PCN#20240220002.1
Qualification of TI CDAT as an additional Assembly site for select devices
Change Notification / Sample Request

PCN Number:	20240220002.1	PCN Date:	February 20, 2024
Title:	Qualification of TI CDAT as an alternate Assembly site for select devices		
Customer Contact:	Change Management team	Dept:	Quality Services
Proposed 1st Ship Date:	May 20, 2024	Sample Requests accepted until:	March 21, 2024*

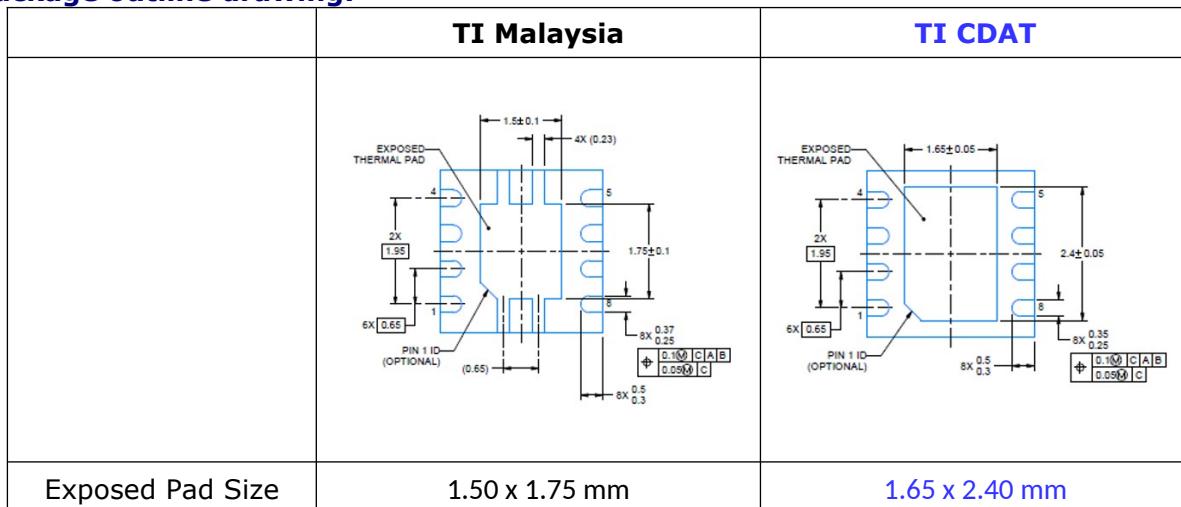
Texas Instruments Incorporated is announcing the qualification of TI CDAT as an additional Assembly site for set of devices listed below. Construction differences are as follows:

Mount Compound	4205846	4207123
Mold Compound	4208625	4222198
